Skyline Park Improvements

Public Workshop #3
Engagement Summary +
Final Concept Plan

Summer/Fall 2021

Block 1 Preferred Concept Plan Presented at Workshop #3

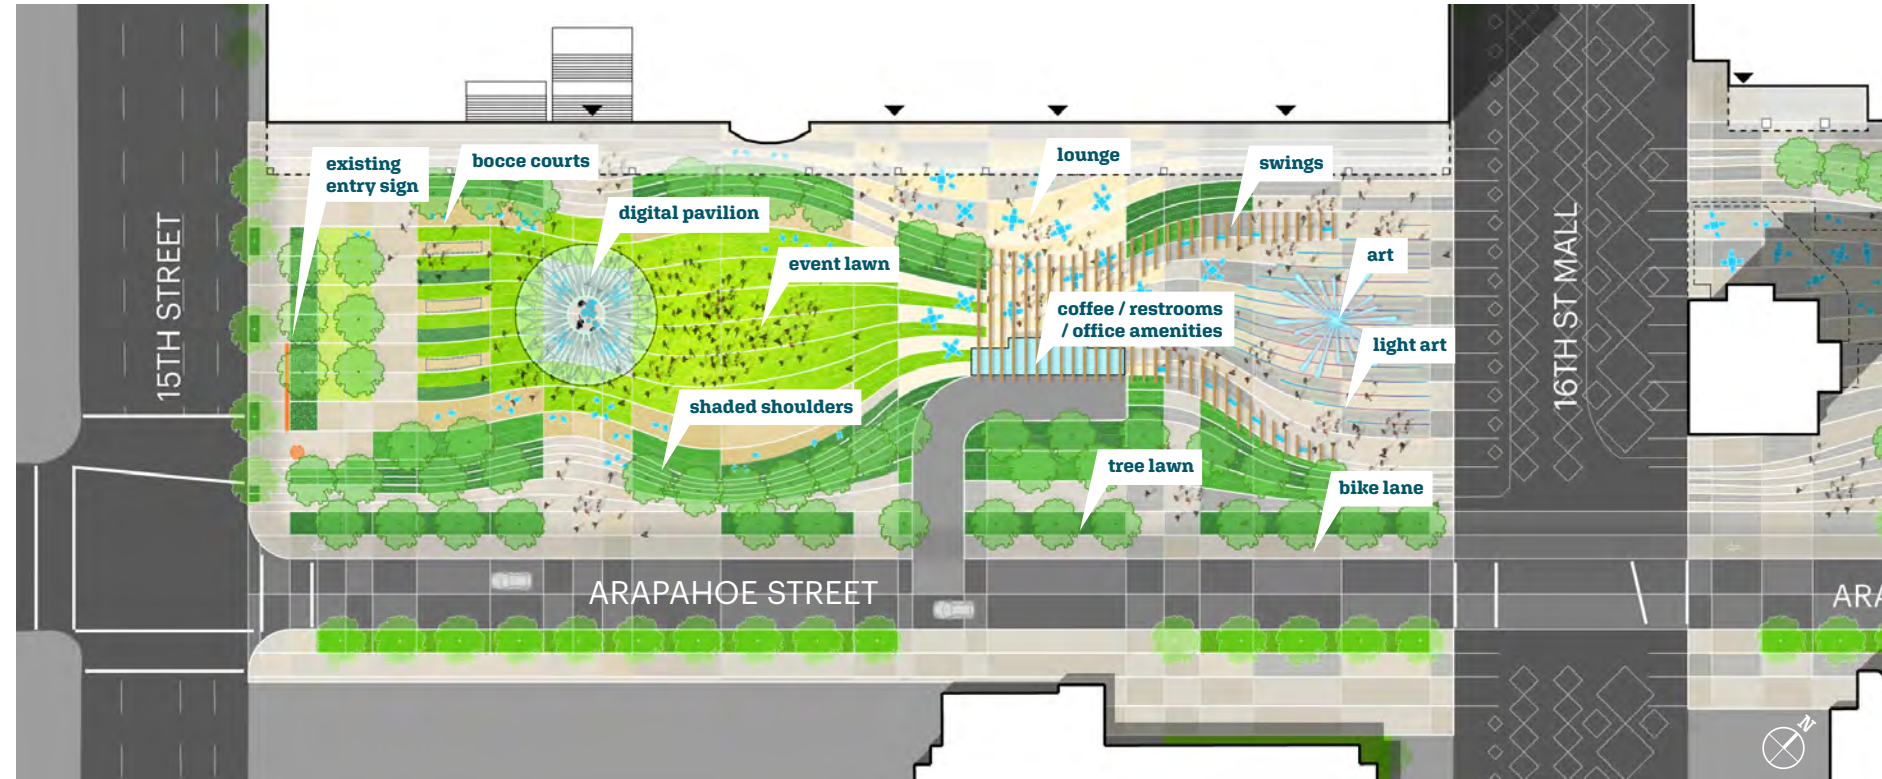
Adding as much greenery (little cement) and shade as possible to make the summer bearable.

I am happy that shade is a prominent feature and design element but I would encourage even more, i.e. maybe an additional layer of trees along the event lawn to fully shade the circulation areas around.

Are there enough benches/chairs/seating for people either working, or grabbing coffee and hanging out?

It would be nice to see fountains or a water feature included.

What will the maintenance costs be for this?

I don't know if the swings are necessary? I guess maybe if each one was big enough for two people to comfortably share.

How will we maintain safety and security in the space?

High-quality urban bicycle parking [is needed].

Block 2 Preferred Concept Plan Presented at Workshop #3

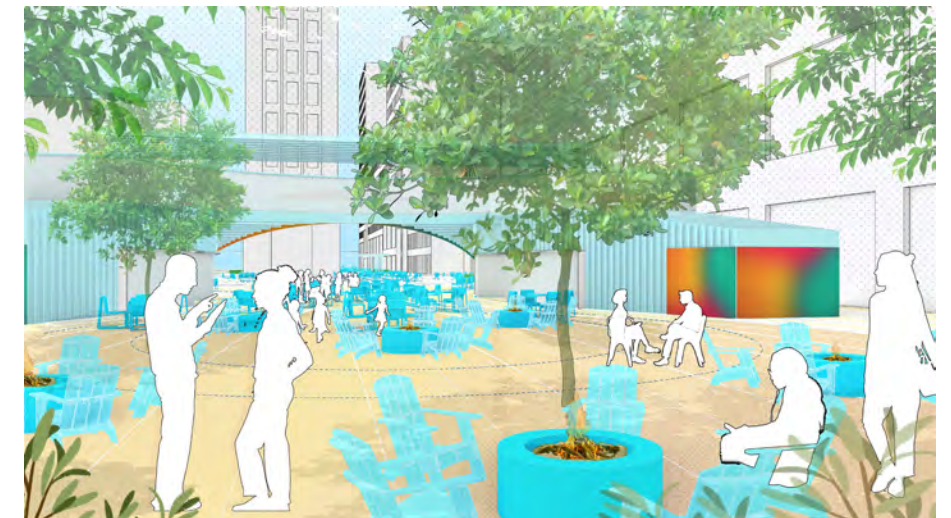
I'm not sure about the bridge structure. Seems like it may be unnecessary and expensive.

I know this is conceptual but the number of trees in the grove feel a little short on supply. I wonder if there is a way to "over-plant" the grove to provide adequate shading in the area that will make the space usable even in early stages of build out.

Again, lots of greenery and shade and little cement.

The Halprin in fountain in Block 2 should be retained in Block 2 instead of the proposed move to Block 3. It could be a focal point of a seating area that supports the coffee shop and use of this portion of the block. I think it's important to keep one of the last remaining pieces of Halprin's work in place.

I do wonder how the fire lounges would be operated or started when in use. I would just want to make sure safety concerns are taken into consideration in how those work/are used by the public.

Providing an overview of any water sustainability built into the water feature design could further improve optics and reduce potable water use.

Block 3 Preferred Concept Plan Presented at Workshop #3

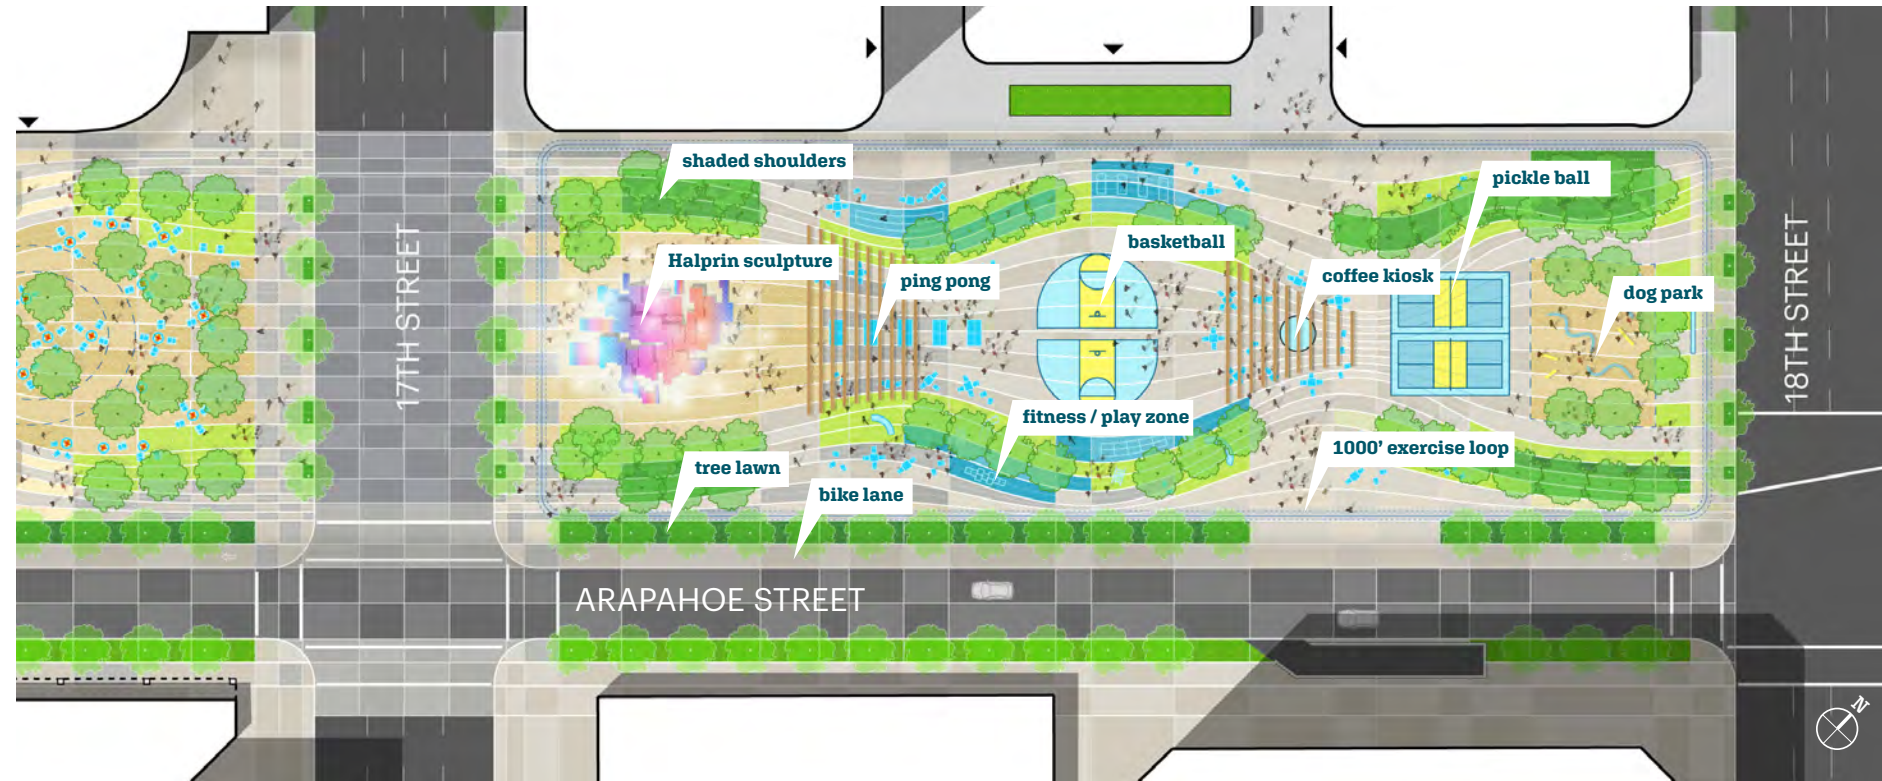
It is too structured. Parks are supposed to be flexible. Basketball is fine, but ping pong and pickle ball courts are too specific. More grass, more trees.

Perhaps the exercise loop could go around all 3 blocks?

Why not create just a sitting/garden park with this fountain sculpture? We have so few areas in the city that promote peace and beauty.

More adaptable sports field so it's not locked into just basketball and pickle ball.

More trees, flowers, bushes.

Sorry to focus on this, but security...is critical if this space is to make downtown desirable again.

There should be more restrooms.

In kids play area would be great to have some kid play structures like slides and climbing things/tunnels/swings etc.

As much as I think it's cool to see so many activities allocated space on the block, it also comes across as crowded and slightly disjointed.

Moving from the Preferred Concept Plan to Final Concept Plan

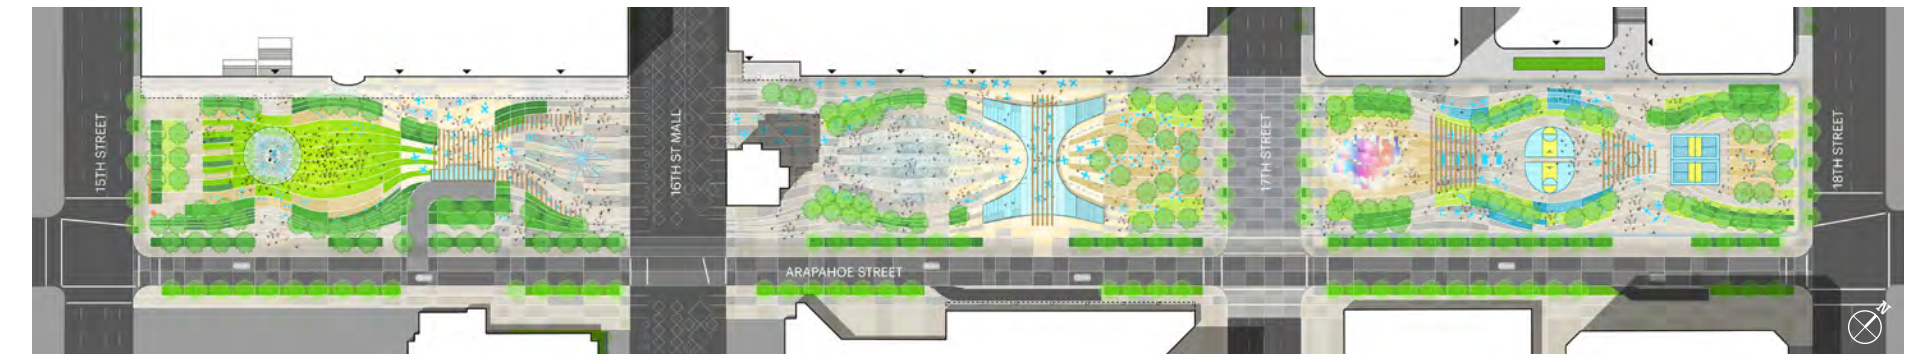
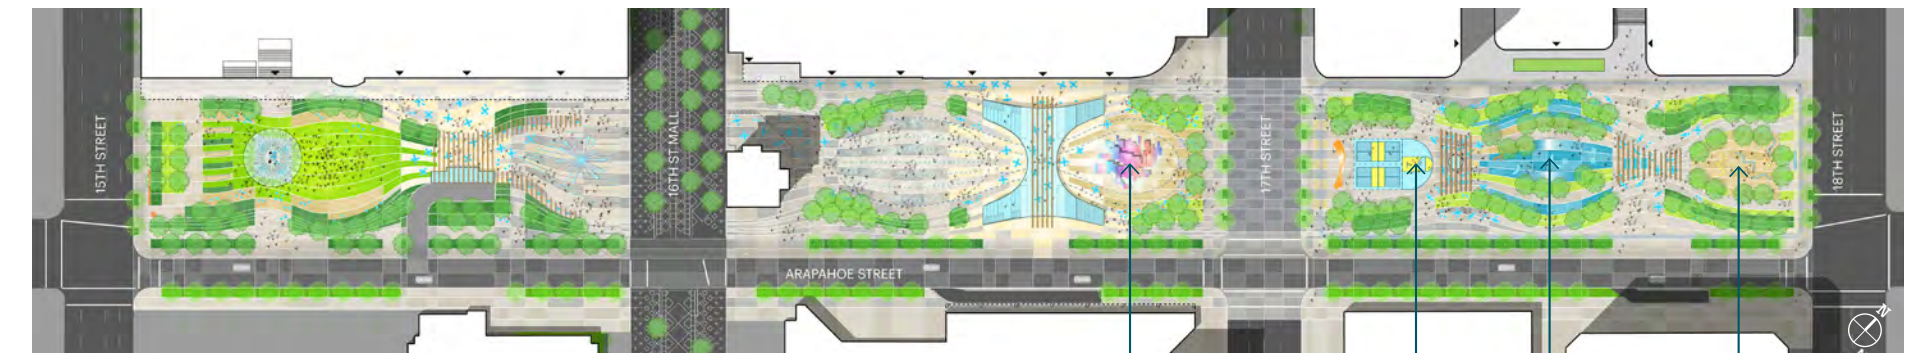
- Retain elements of the original Halprin Sculpture on Block 2
- Reduce the quantity of elements on Block 3
- Add additional trees and shade

Halprin sculpture retained on Block 2 (rather than being moved to Block 3). It will still be re-imagined at-grade with elements like mist and light.

Sports courts and coffee kiosk moved towards 17th St., along with new gateway artwork, as lively attractions to draw visitors across from Block 2.

Expanded fitness and play zone in the center of the block, shaded by trees and shade canopies on the sides.

Expanded dog park, with added green space and additional shade trees.
